Scott G. Fitzwilliams, Forest Supervisor  
White River National Forest

March 21, 2018

The following are comments regarding the Copper Mountain Resort (POWDR Corporation) proposal to replace the American Eagle and American Flyer lifts. CMR's March 5, 2018, press release describes that, "Copper Mountain, and its parent company, POWDR, today announced continued enhancements to the way guests access the mountain's world-class, naturally-divided terrain. The planned upgrades to replace the American Eagle and American Flyer lifts with high-speed combination and bubble-style lift service are slated to debut for the 2018-2019 ski season. Plans to replace the two lifts are subject to U.S. Forest Service approval, and further details will be available in the coming days." The Forest Service scoping notice states that, "CMR proposes to implement these projects during the summer of 2018."

Far East Lot as currently developed adjacent to the CDNST travel route

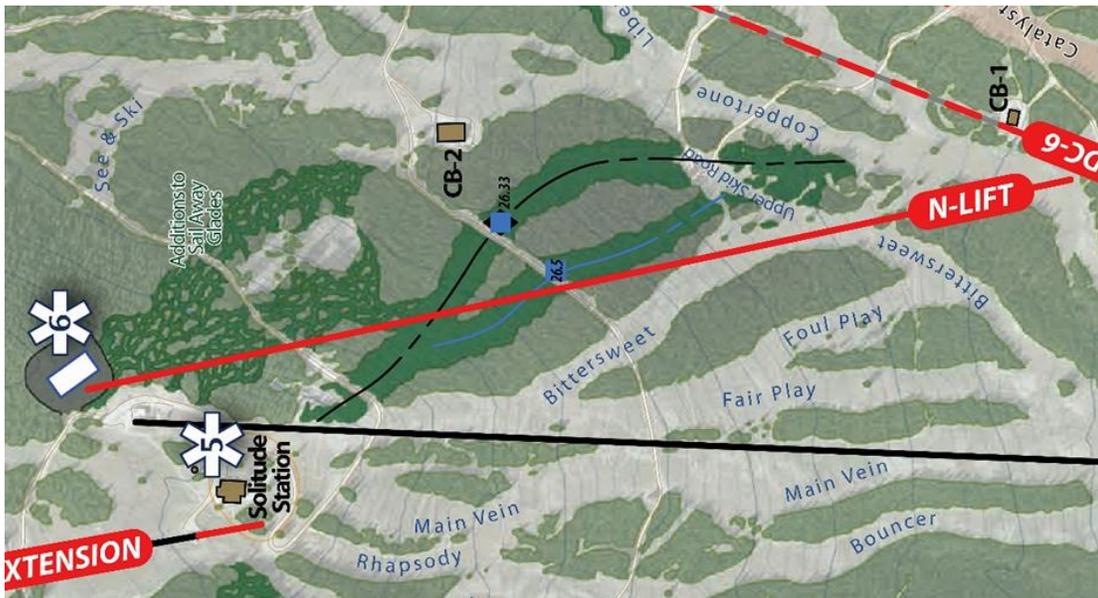
An updated Master Development Plan must recognize the significance of the Continental Divide National Scenic Trail (CDNST) as it passes through the resort Special Use Permit area.<sup>3</sup> I am concerned with scenery effects of the Far East Parking Lot (aka Corn Lot) on CDNST values. The effects on CDNST values of the Tenmile Creek Facilities Improvements and Restoration Project should be mitigated by applying visual screening best management practices. Further development of the Far East Lot should be suspended and no permit issued or operating plan approved for expansion of the lot until the CMR Master Development Plan is amended or revised to address the requirements of the National Trails System Act as implemented through the 2009 CDNST Comprehensive Plan, FSM 2353.4, FSH 1909.12 part 24.43, and Federal Register Notice of final amendments to the CDNST Comprehensive Plan and final directive (74 FR 51116). Again, my primary concern with the Far East Lot is mitigating visual effects.
